Our File: 9506

June 10, 2014

**Re: Letter - Response to Burnside Review of Summary of Drilling and Testing of New Well M15 at Hidden Quarry Site (Burnside Response April 8, 2014)  
Harden Response to Burnside Review of Hydrogeological Summary Report (Burnside Response April 9, 2014)  
Hidden Quarry Site for Township of Guelph/Eramosa  
Burnside File No.: 300032475.0000**

**Figure 1: Streamflow Stations SW3 vs SW4**

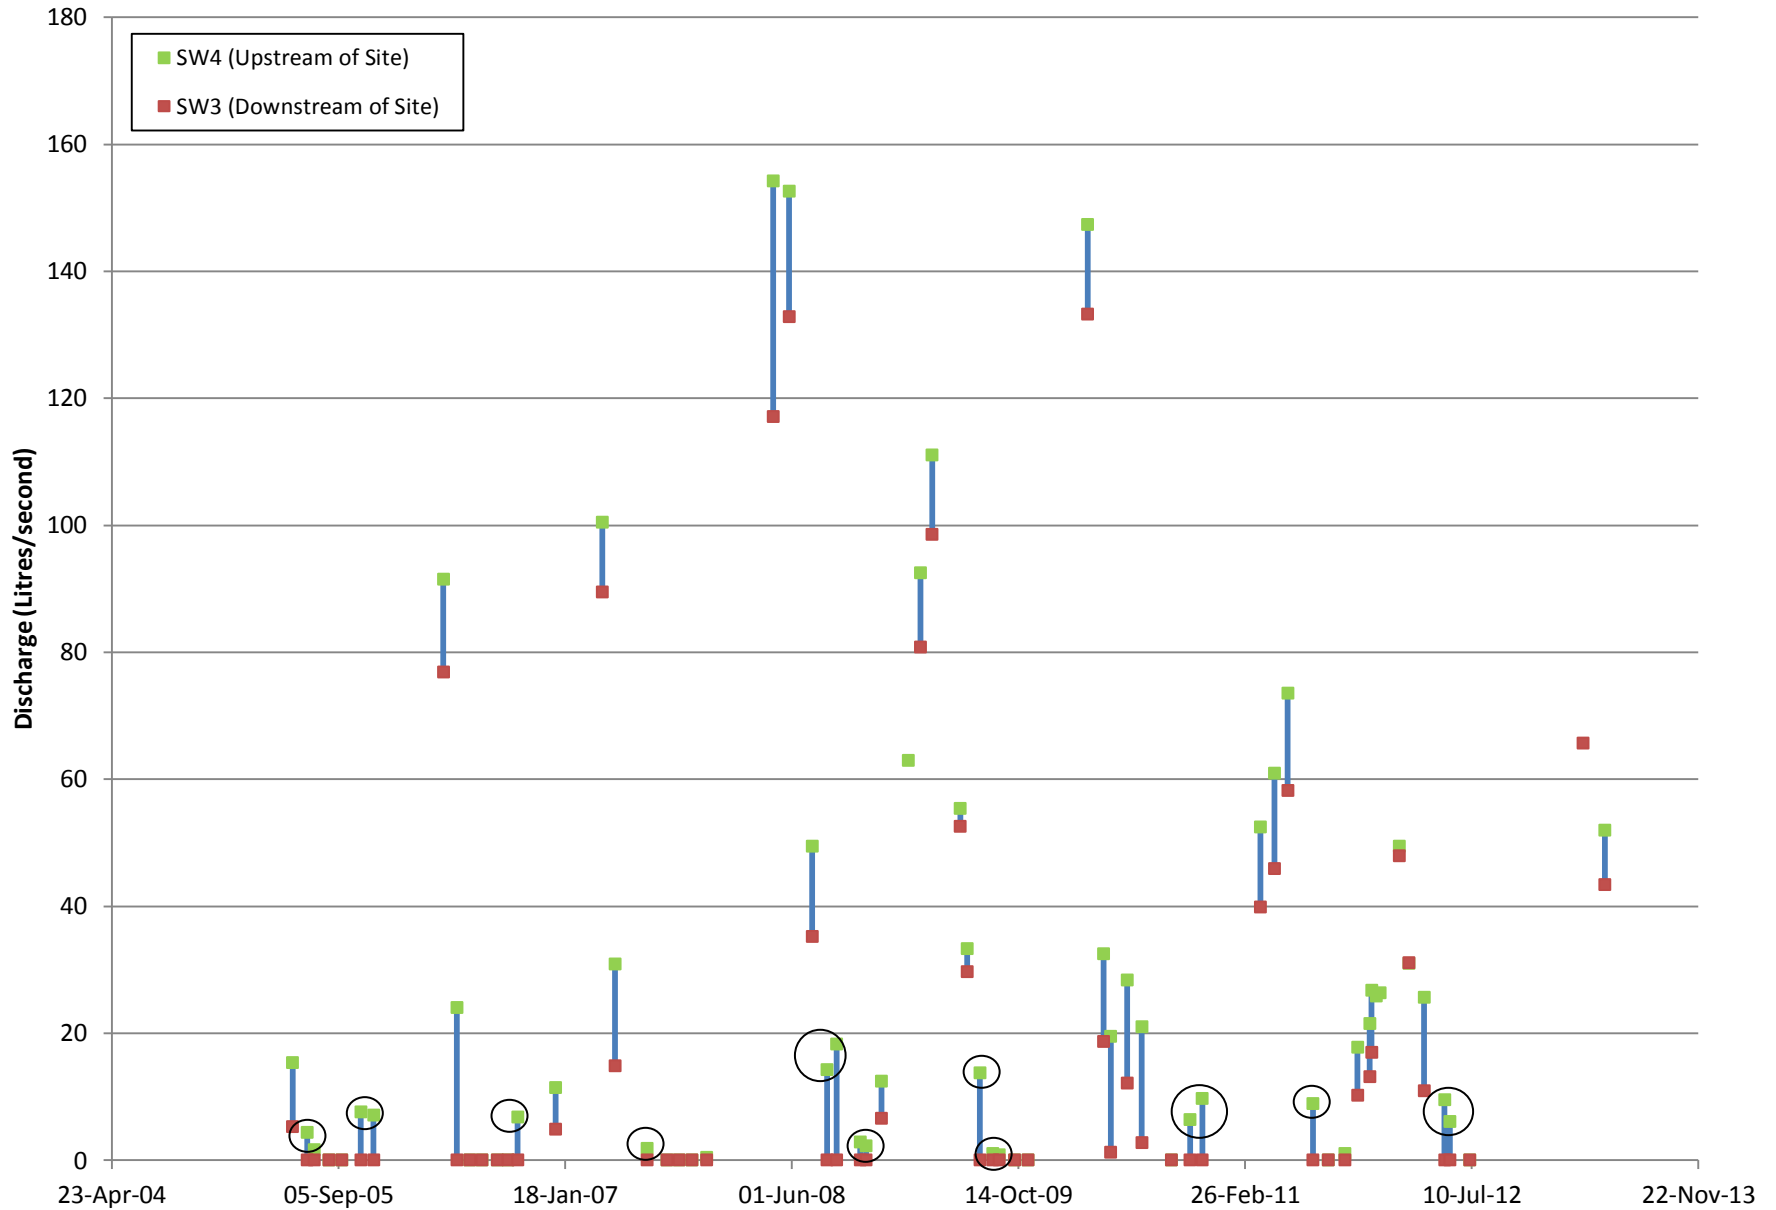
Streamflow measurements have been obtained regularly since 2005. As shown on Figure 1, Tributary B only loses all of its water (no flow at SW3) when the incoming flow at SW4 is less than approximately 20 L/s. With flows of greater than 20 L/s, flow is found in all on-site reaches of Tributary B. Table 1 summarizes observations of flow conditions where streamflow has been observed to cease within different reaches of Tributary B. The surface water station locations are shown on Figure 2. Our observations are that the stream will cease to flow in various reaches within the proposed quarry boundaries depending on the incoming flow at SW4. This gradual loss of water supports the

Our conclusion is that it is unnecessary to instrument Tributary B with more continuous water level devices than already agreed upon. It has already been agreed upon to instrument two locations of the stream with continuous water level recording devices at SW4 and SW8.

**Figure 2:**

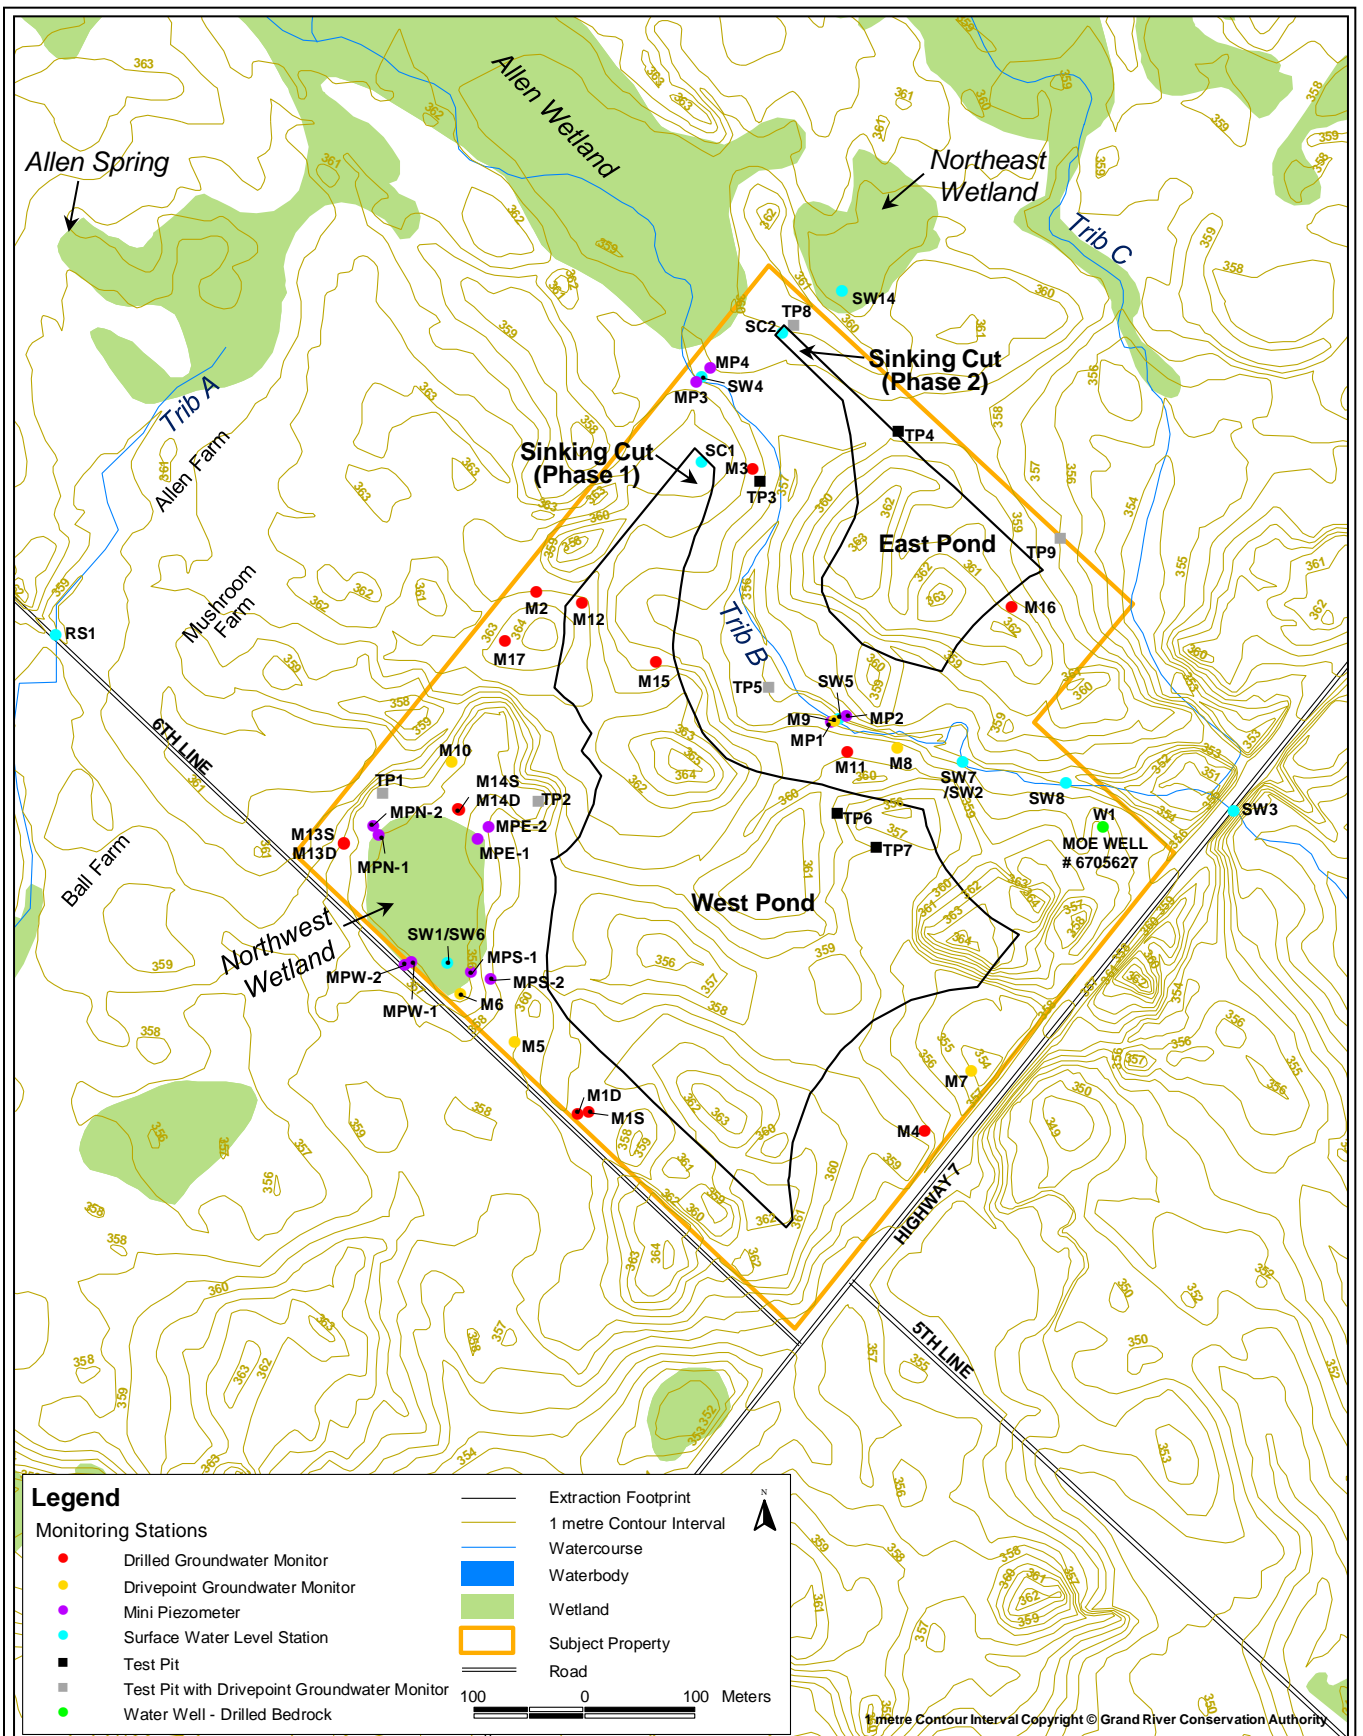
As suggested by Burnside and Associates, a dedicated monitoring well completed as an open hole to 327 m AMSL will be installed within the quarry limits. This well will be installed as M17 at the location shown on Figure 2. M17 will be installed upon approval of the quarry. This monitor has been added to the monitoring program.

**Figure 3: Installation of M15 versus Results of Flow Test**

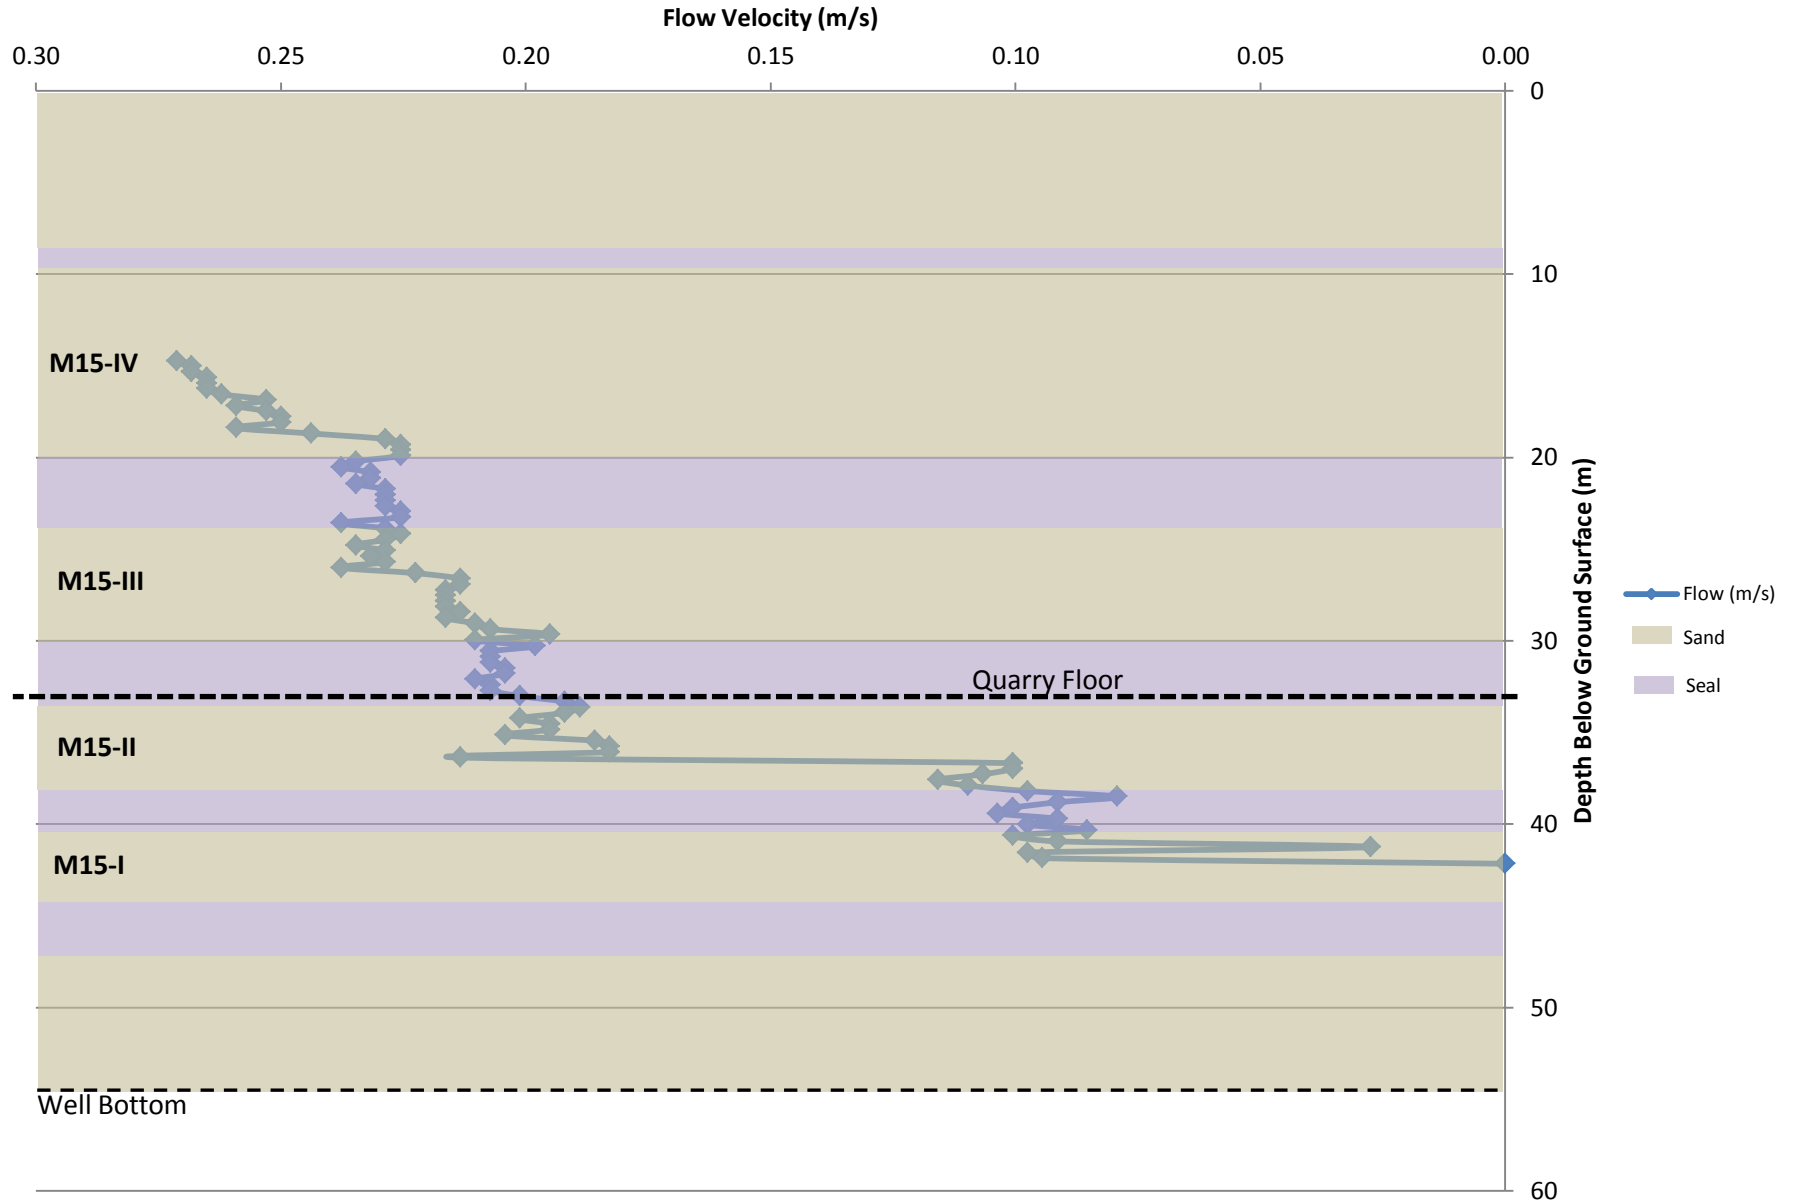
As shown on Figure 3, the test intervals were designed to isolate major fractures and water producing sections of the aquifer identified in the video log and flow test.

The greater value hydraulic conductivity intervals M15-I and M15-II correspond with the greater flow velocities as observed in the flow test as shown on Figure 3. Approximately 75% of the flow to the well comes from the aquifer represented by test intervals M15-I

Figure 9: Maximum Rate of Bedrock Extraction

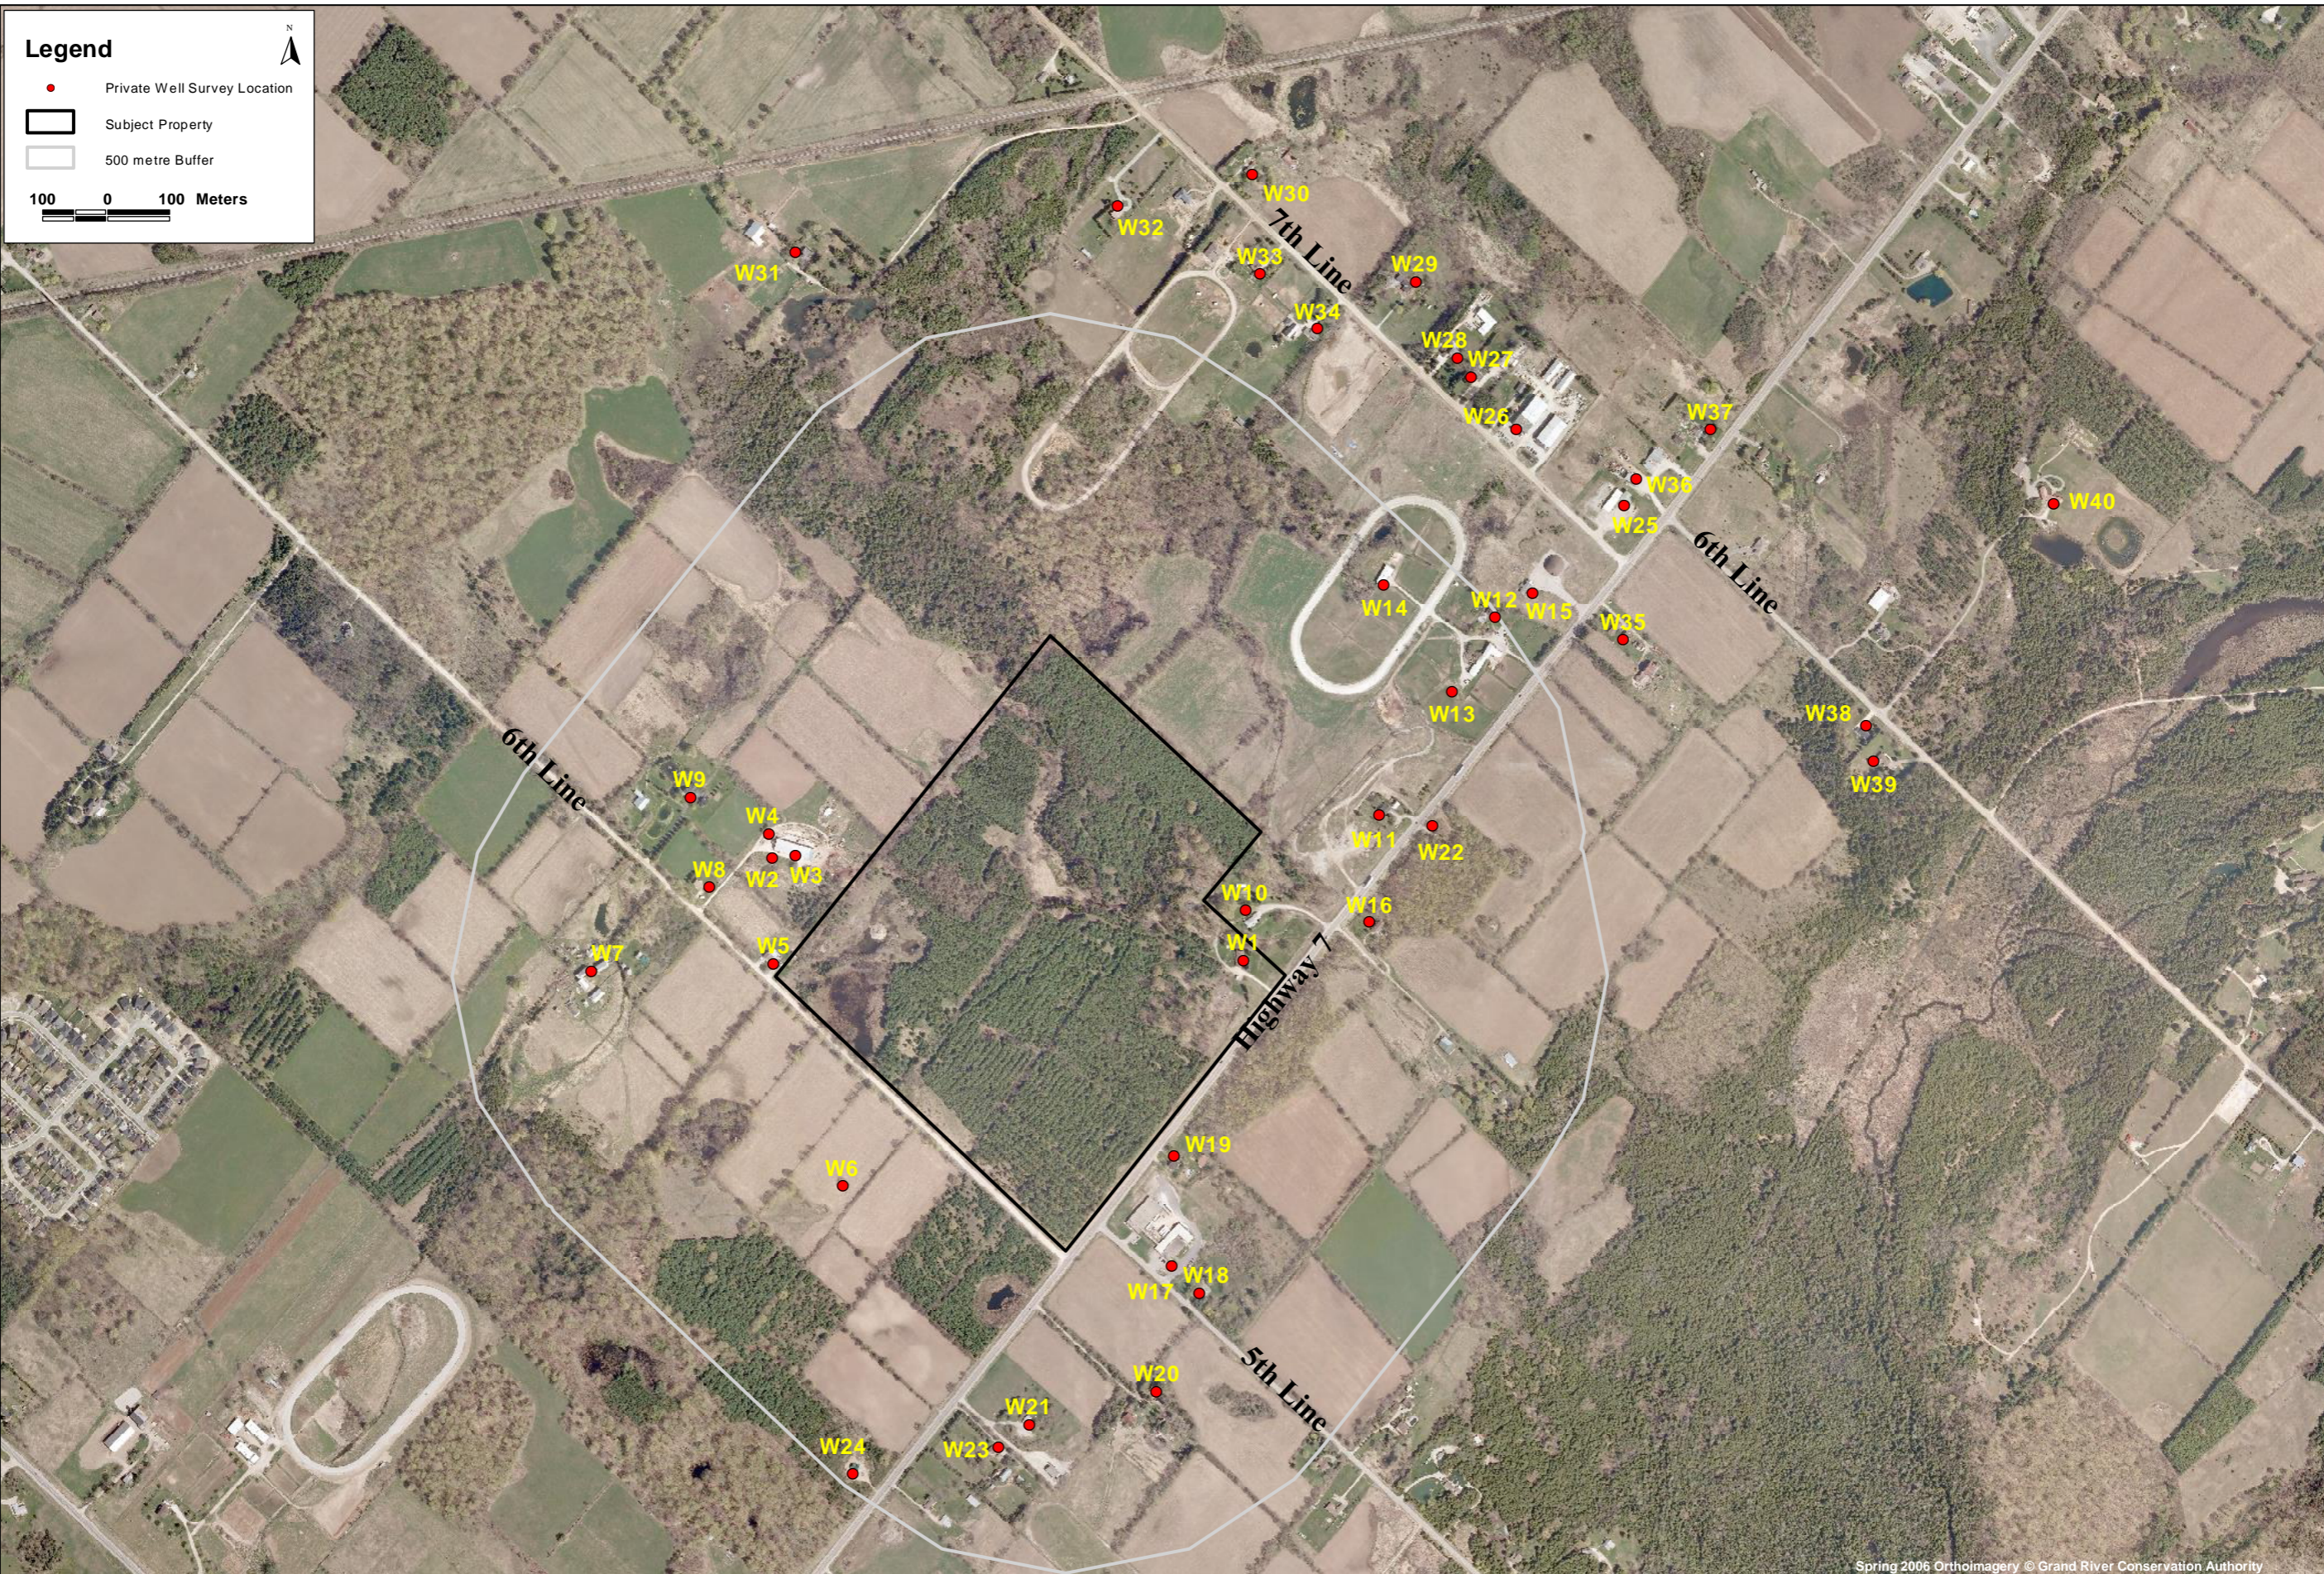
Quarry activities will commence in the northernmost extent of the site and west of Tributary B. As shown on Figure 9, groundwater monitor M3 and M16 will initially be downgradient of the sinking cut and ultimately M15 and M4 will be downgradient of the quarry pond. It will take approximately four years at maximum extraction levels to extend the quarry from the sinking cut near M3 to the western extent near M1. The proposed semi-annual water quality monitoring at M3, M16 and M15 will be able to detect water quality changes well in advance of water moving off-site. As shown on Figure 9, even after the end of four years (Phase 1 of the quarry), the only private wells downgradient of the quarry will be W10 and W16. Ultimately M4 will also be downgradient of the quarry pond(s). Through this monitoring effort, water quality changes in the aquifer will be observed and mitigative measures taken if necessary.
